**Controller Evaluation of CPDLC  
Services Implemented on the Display  
System Replacement (DSR)  
Workstation:**

**Study 1 -- Initial Assessment of Services  
Transitioned From the PVD and Design  
Development for Additional Services**

DOT/FAA/CT-TN99/11

FIGURE 1. DSR DATA LINK KEYBOARD

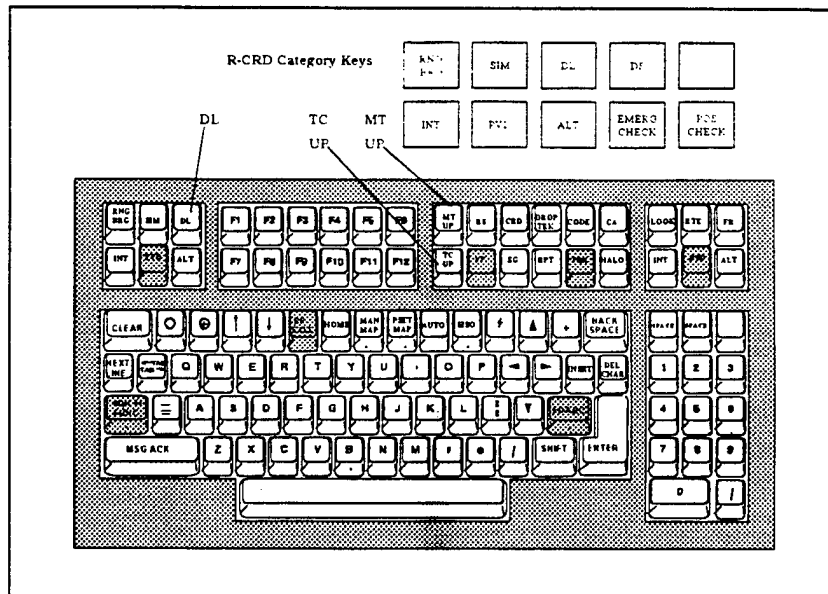
The consensus of the group was that, for CPDLC I, the *MT UP* and *TC UP* keys should be relocated to the far right of the bank of 12 hard-labeled function keys in which they were positioned for testing. The controllers noted that this location was preferable because it would permit rapid access to the keys when making entries on the numeric keypad and when using the routinely employed function keys located in the six-key bank to the right of the keyboard.

A majority of the participants agreed that the Data Link key labels were meaningful and not susceptible to confusion with other key designations. While color coding of the key caps to enhance distinctiveness was discussed during the debriefing, it was noted that two colors had already been added to the DSR key caps, and that proliferation of the practice may diminish the value of color as an aid to key identification.
